ADDENDUM

**FINAL ENVIRONMENTAL IMPACT REPORT
(SCH No. 2012111083)**

**SAN JOAQUIN RIVER RESTORATION PROGRAM:
SALMON CONSERVATION AND RESEARCH FACILITY AND
RELATED FISHERIES MANAGEMENT ACTIONS PROJECT**

March 2015

Figure 4. Engineering drawings of expected layout for the building plan and equipment detail

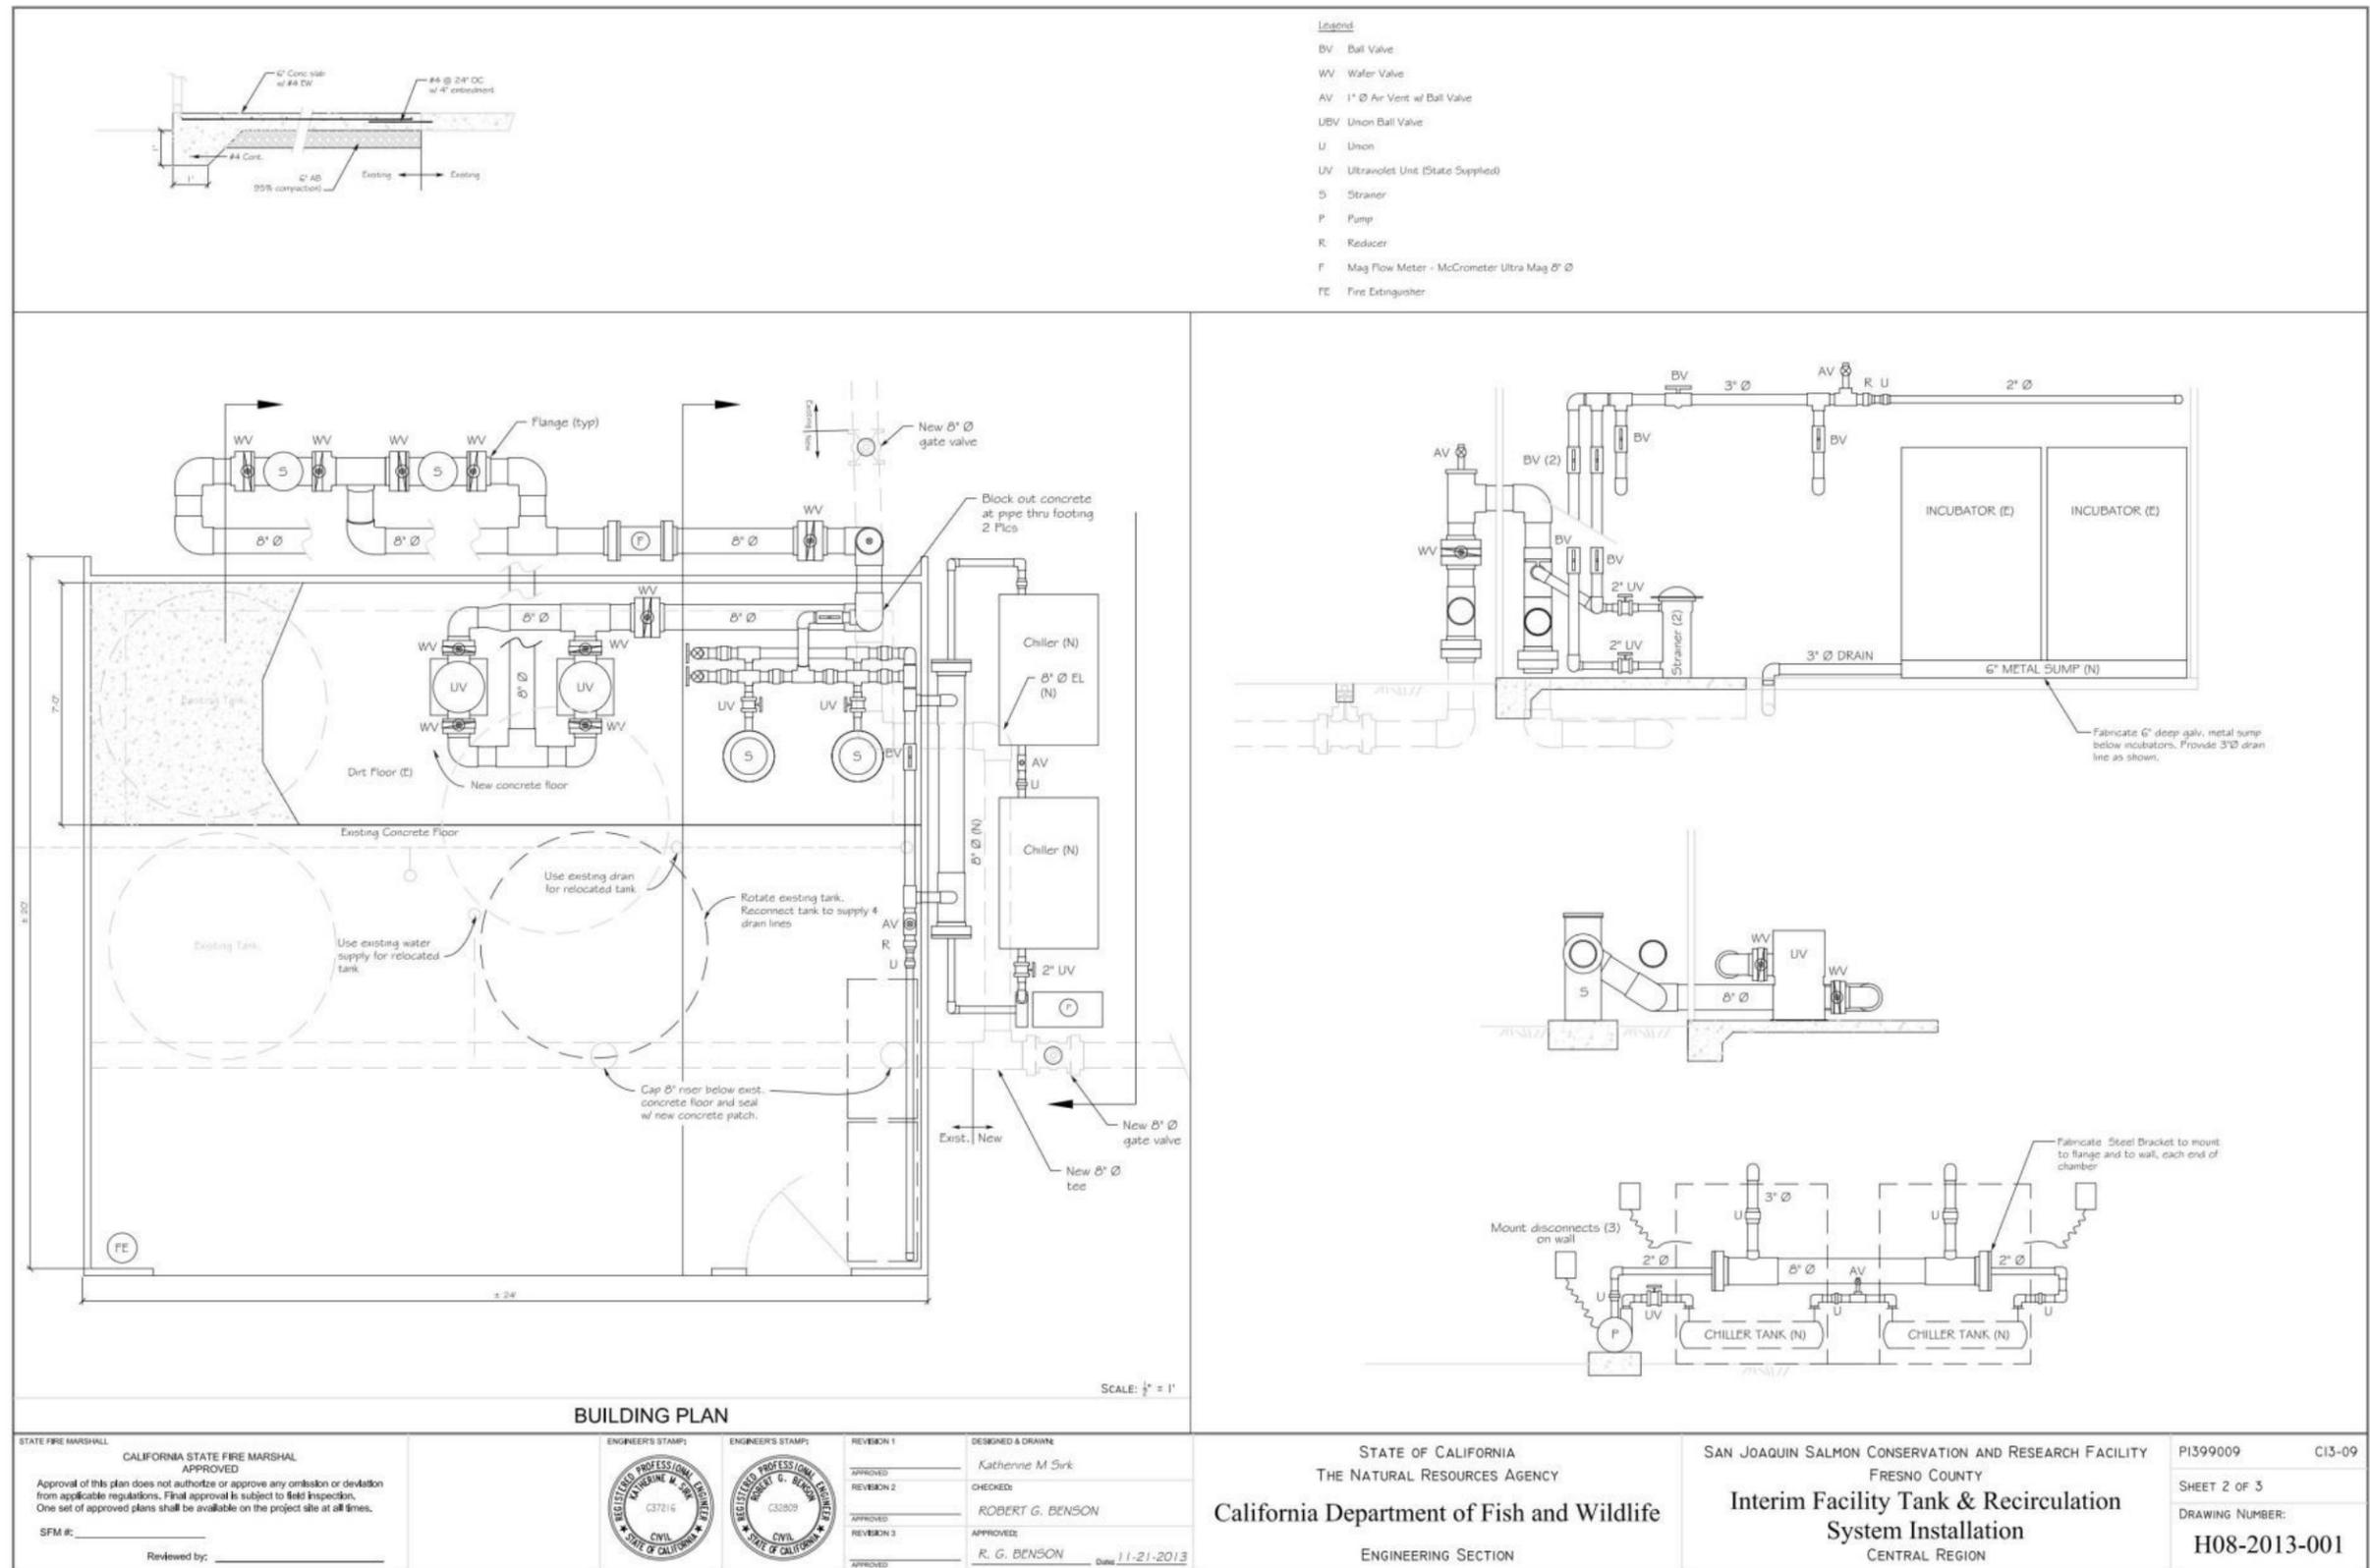
The concrete floor slab will be extended by 192 square feet (8-foot by 24-foot). Interior above ground interior plumbing will be improved, two micro-strainers and indoor UV units will be installed to clean incoming water, and new egg incubation trays will be installed. New electrical connections will be installed for new equipment. Two outdoor 8-inch basket strainers will be installed on the north side of the shed to remove debris

Figure 6. Recirculation and chiller for translocation and rearing – Concept Design

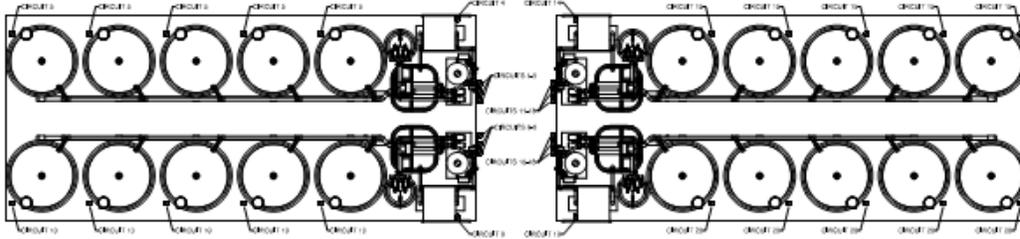
Proposed modifications include the installation of water recirculation/chiller equipment for the incubation trailer and new tanks with recirculation/chiller equipment for rearing and holding salmon. The systems are not yet at final design so additional modifications to the facilities may be necessary. Figure 6 presents a concept design for the proposed new tanks and recirculation/chiller system. CDFW would permit, provide, install and maintain all new equipment. Reclamation would provide heavy construction equipment, space, access, and utility infrastructure (i.e., water supply and electricity) to accommodate the proposed modifications.
